The Safety and Enforcement Division (SED) of the California Public Utilities Commission conducted a G.O. 112, Operation and Maintenance Inspection of Southern California Gas Company's (SoCalGas) Mountain Pass Distribution Area from April 8, 2019 to April 19, 2019. The inspection included a review of both companies' written O&M procedures pursuant to G.O. 112-F, Reference Title 49, Code of Federal Regulations (CFR), Parts 191, 192 and 193

# 2019 SoCalGas Mountain Pass Distribution Area 4/8/2019 to 4/19/2019

#### **Notice of Probable Violations**

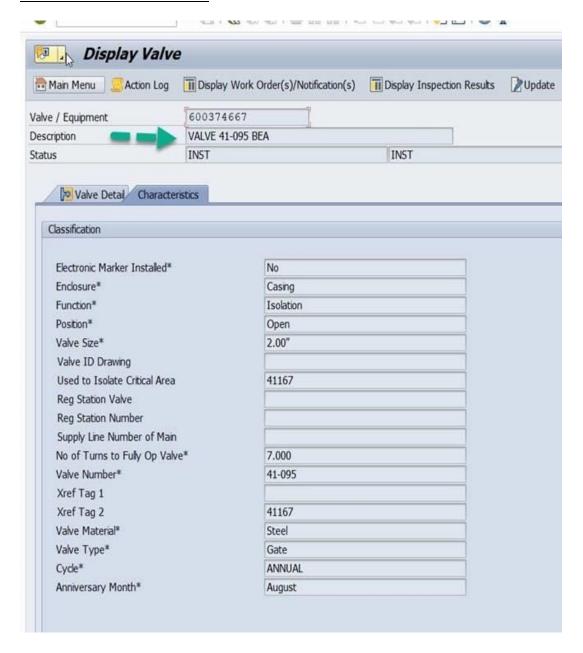
7. During the field inspection, SED observed that vault #1312 had cracks on the concrete walls within a regulating station. In addition, the vault's cover/lid had a broken spring support. SCG's Gas Standard 223.0210, Vault Maintenance and Inspection, Section 4.6, requires employees to contact the Mechanical, Civil and Structural Design Group in Engineering Design to assess the integrity of the structural condition of the vault for such conditions. SED recommends that SCG take remedial actions to address SED's concerns.

SoCalGas recognized the conditions identified by SED. However, the conditions identified within the vault were considered minor cracks and did not warrant contacting the Mechanical, Civil and Structural Design Group in Engineering Design. There was no exposed rebar or presence of large crushed concrete, as provided in Section 4.6:

4.6. Check structural condition of vault, including cracks, crumbling concrete, crushed concrete, exposed rebar or evidence of foundation settlement or rood deformation. If there is any exposed rebar or large crushed concrete, contact the Mechanical, Civil and Structural Design Group in Engineering Design.

SoCalGas takes the safety of their employees and assets very seriously and SAP Work Order 540000329706 was initiated to replace the vault lids and repair the crack on the vault wall. On June 10, 2019 a third-party construction crew replaced the lids and patched the vault wall. Pictures of completed work can be found in the **Appendix**.

# Valve 41-167-3 SAP Attributes

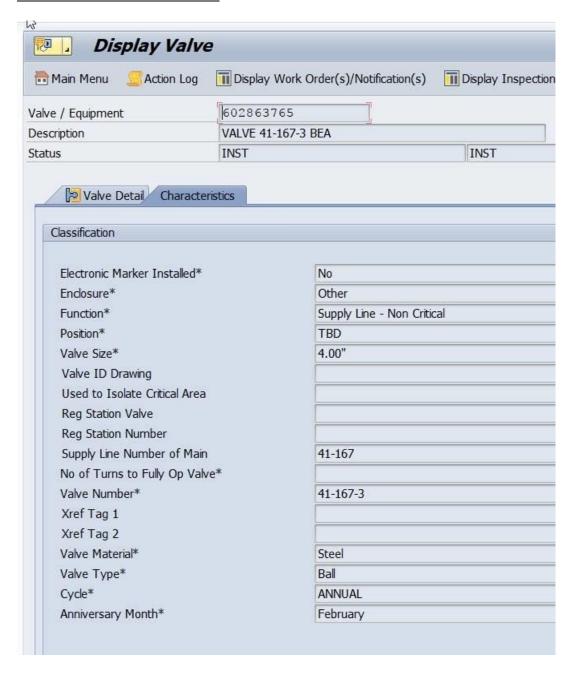
2. During the field inspection of valve #41-163-7 at N. Hathaway St / Morongo Road, Banning, SED found that the MDT did not specify the number of turns needed to exercise the valve, resulting in a postponement of the valve inspection. SED found that SCG failed to provide its employee with the necessary instructions to perform the inspection. Therefore, SCG is in violation of G.O. 112-F, Reference Title 49 CFR Part 192, §192.605(a) and §192.605(b) (3).

Based on the information in the system, the crew had the available information to complete the order per Gas Standard 184.16 / *Valve Inspection and Maintenance – Distribution* section 4.2.2 GEAR OPERATED. Full valve operation is not conducted during the inspection. Thus, SoCalGas contends the number of turns needed to fully operate a valve is not required to complete the inspection. In the

event that a valve would need to be fully operated, the number of turns would be captured by the crew and documented. An SAP screen shot of valve attributes is provided in the **Appendix**.

SoCalGas records, as well as notes from the 2019 Mtn. Pass CPUC SED inspection, indicate the correct valve number located at N. Hathaway St./Morongo Rd. is #41-167-3. The valve is identified as a 4" gear operated ball valve.
